**TITLE:** **SPECIAL PERMIT NO. 1999A**, an amendment to the **Wilderness Hills Community Unit Plan**, requested by Engineering Design Consultants on behalf of Lincoln Federal Bancorp, Inc., on property generally located northeast of the intersection of South 27<sup>th</sup> Street and Whispering Wind Boulevard.

**LINCOLN CITY/LANCASTER COUNTY PLANNING STAFF REPORT**

**-REVISED STAFF REPORT-**

**P.A.S.:** Special Permit #1999A for Community Unit Plan.

PRELIMINARY  
 SHEET 2 OF 16

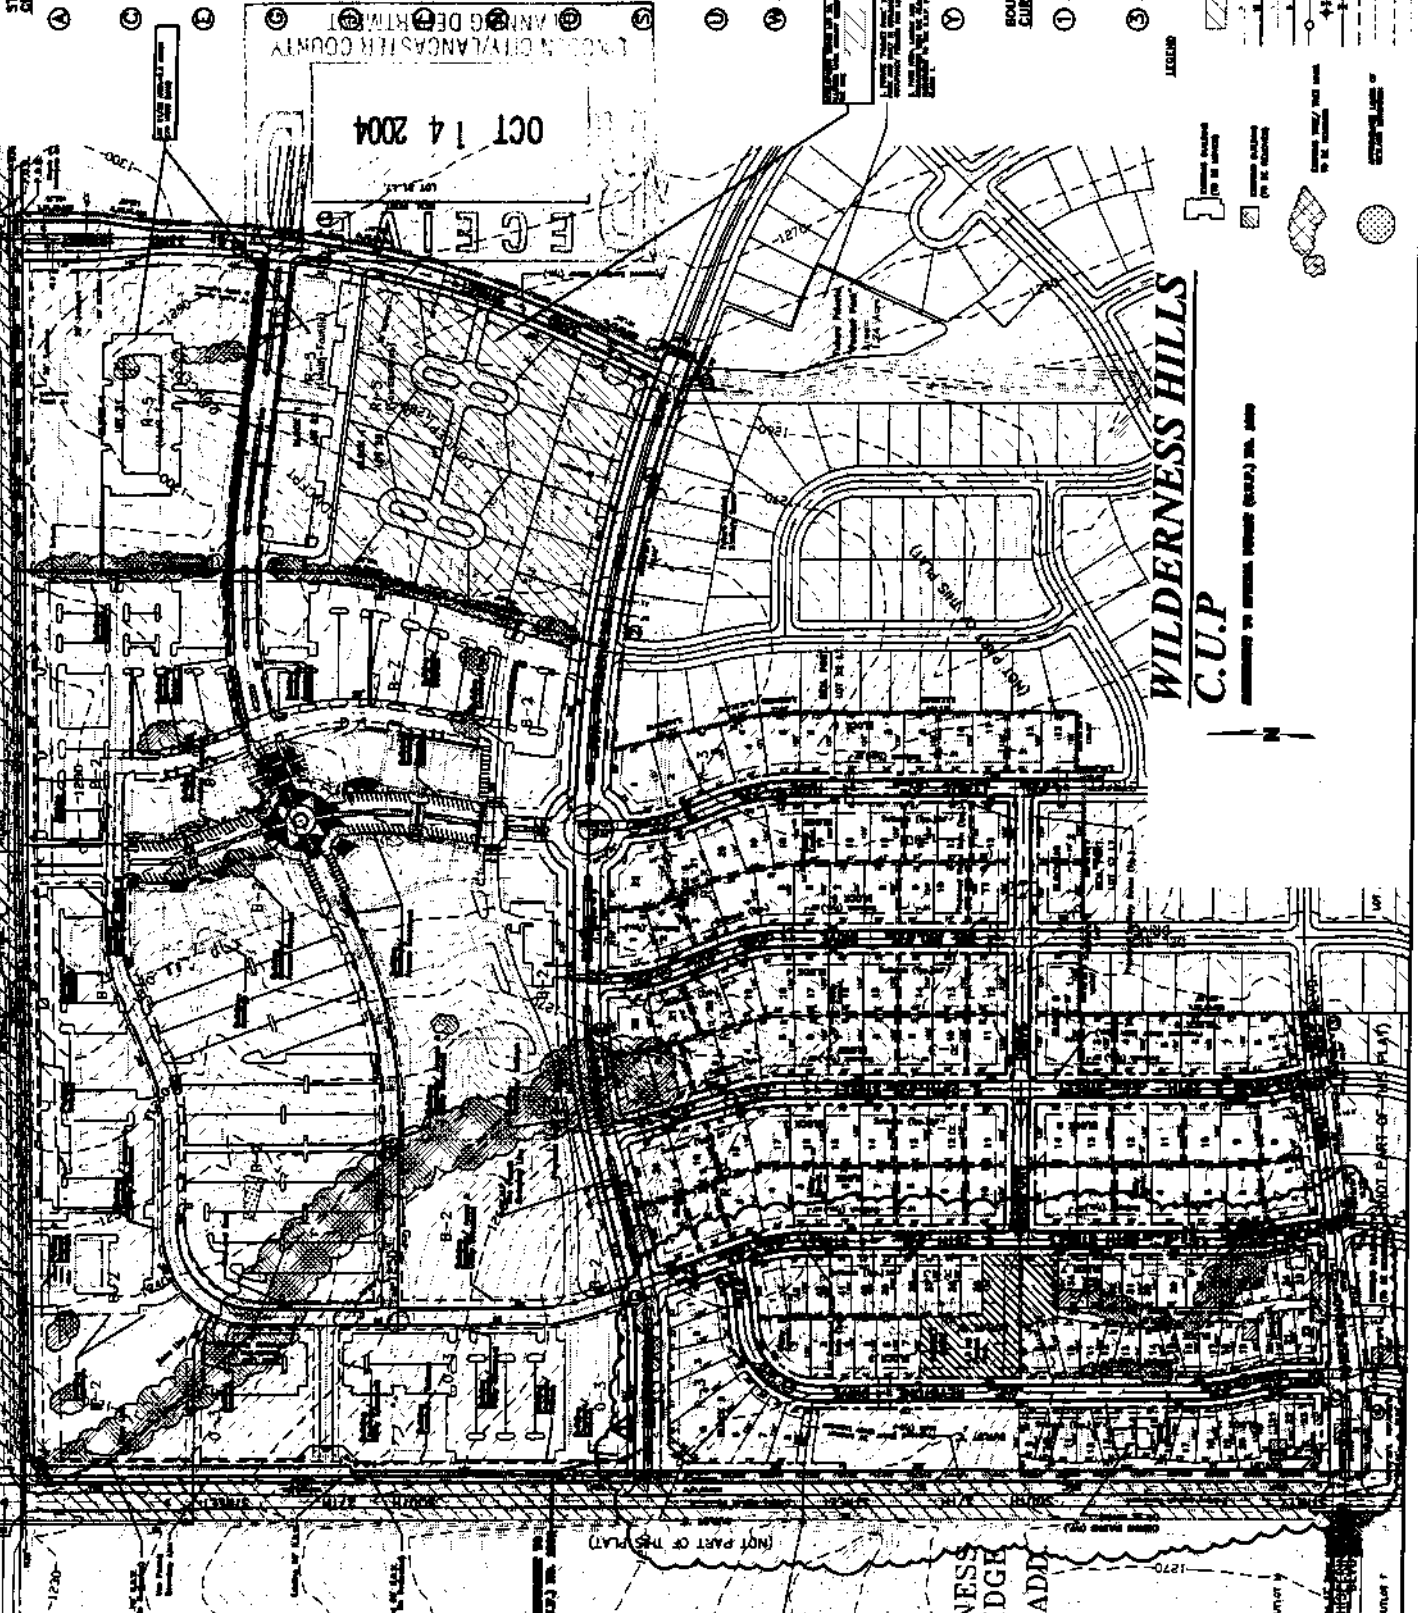
1. After the applicant completes the following instructions and submits the documents and plans to the Planning Department and the plans are found to be acceptable, the application will be scheduled on the City Council's agenda:
  - 1.1 Revise the site plan to show:
    - 1.1.1 Revise the references in General Notes #22 and #23 and in CUP Site Note #7 from "Two-family" to "Single-family Attached."
    - 1.1.2 Revise the Waiver Table by deleting waivers #1 and #5, and by amending #6 and #7 to note that the rear setback for Lots 9-23, Block 2 and Lots 8-34, Block 7 is adjusted to 5'.
    - 1.1.3 Revise the title of the Waiver Table to read "WAIVER TABLE (CITY OF LINCOLN LAND SUBDIVISION AND ZONING REGULATIONS)."

- 1.1.4 Indicate the purpose of Outlot C, Block 2.
- 1.1.5 Show a sidewalk extending across both Outlots C and D connecting the sidewalk along South 27<sup>th</sup> Street to the sidewalk along South 28<sup>th</sup> Street in line with Rockport Drive.

- 1.1.6 Add Note #10 to CUP Site Notes that reads "THE LANDSCAPE SCREEN ALONG SOUTH 27<sup>TH</sup> STREET WILL MEET OR EXCEED THE REQUIREMENTS OF THE CITY OF LINCOLN DESIGN STANDARDS, CHAPTER 3.5, SECTION 7.4. SCREENING FOR LOTS 1-5, BLOCK 2 MUST ALSO MEET OR EXCEED THAT STANDARD, AND IF A FENCE IS ERECTED ALONG REAR PROPERTY LINES PLANTS MUST BE INSTALLED BETWEEN THE SIDEWALK AND THE FENCE TO PROVIDE A MINIMUM 50% SCREEN TO 6' IN HEIGHT. THE PROPERTY OWNERS OF EACH LOT MUST MAINTAIN THE PLANTS."

- 1.1.7 Show the additional easements per the L.E.S review.
- 1.1.8 Revise the typical street cross sections to include sidewalks.
- 1.1.9 Label the area along South 27<sup>th</sup> Street near the intersection with Wilderness Hills Blvd to be dedicated as right-of-way

- 1.4 The street name change to Keystone Drive must be approved by the Street Name Committee.
- 1.5 Revise the legal description on Sheet 18 of 18 to include the names of the I.T. lots involved in Special Permit #1999A for the Wilderness Hills community unit plan.

**WILDERNESS HILLS  
TOWNHOUSE EXHIBIT  
LINCOLN, NEBRASKA**

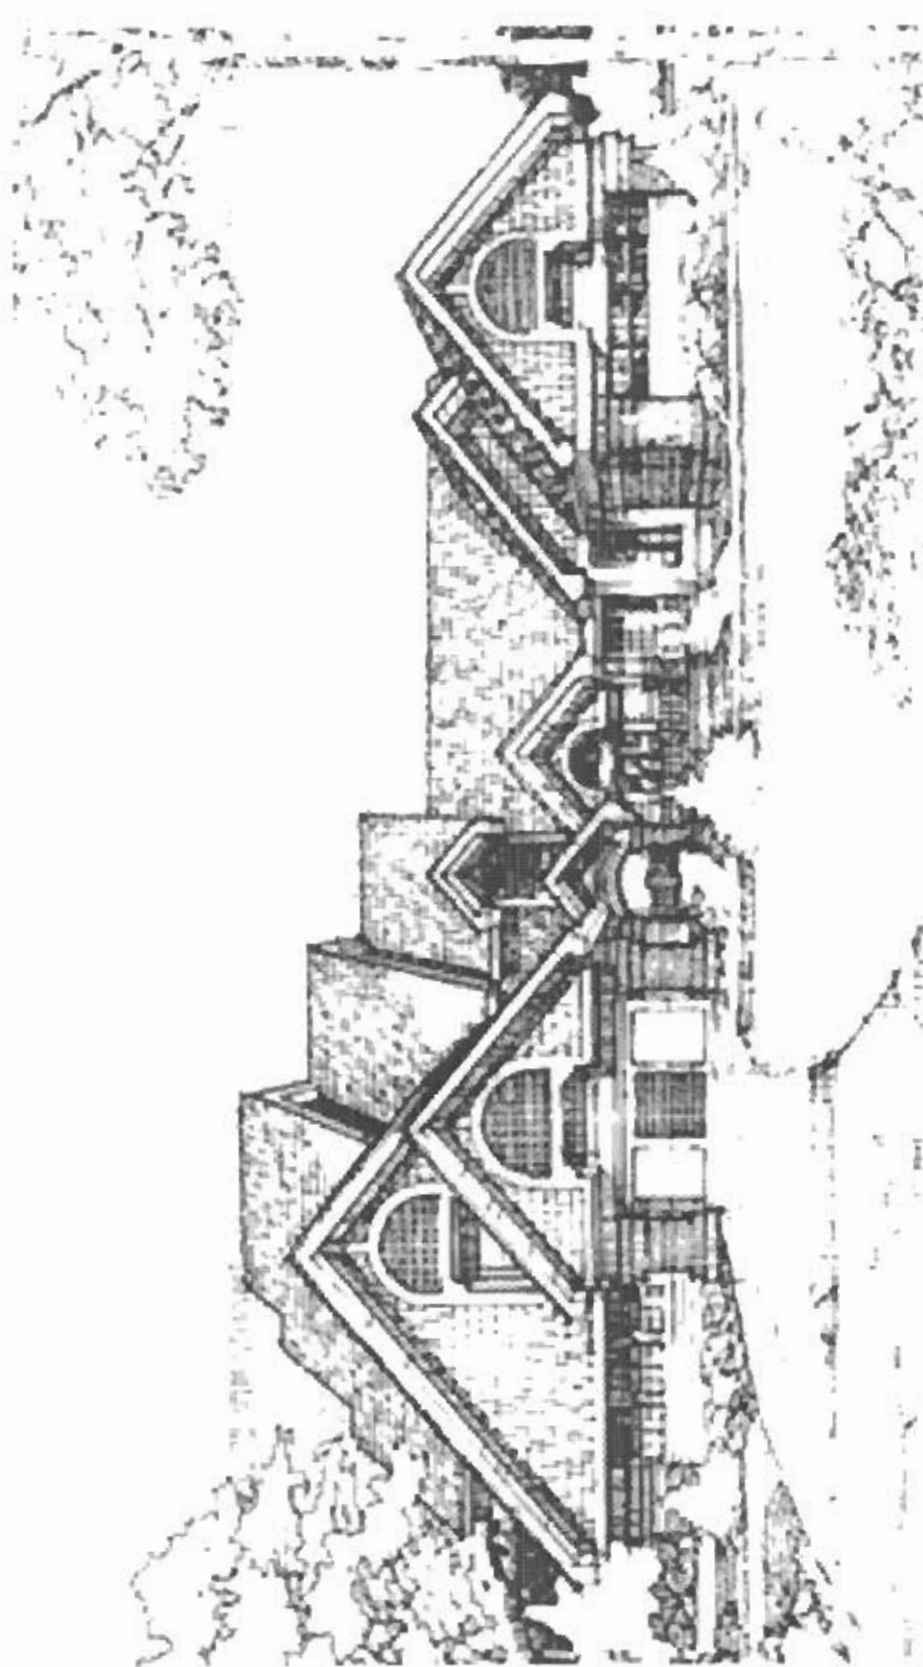
- d. A waiver is requested to Title 26, Section 26.23.140 to waive the requirement that all lot lines must be radial to the streets for Lots 8 – 34, Block 7 and Lots 9 – 24, Block 2 to provide a unique neighborhood concept for the Wilderness Hills development (See enclosed exhibit showing proposed building orientation).
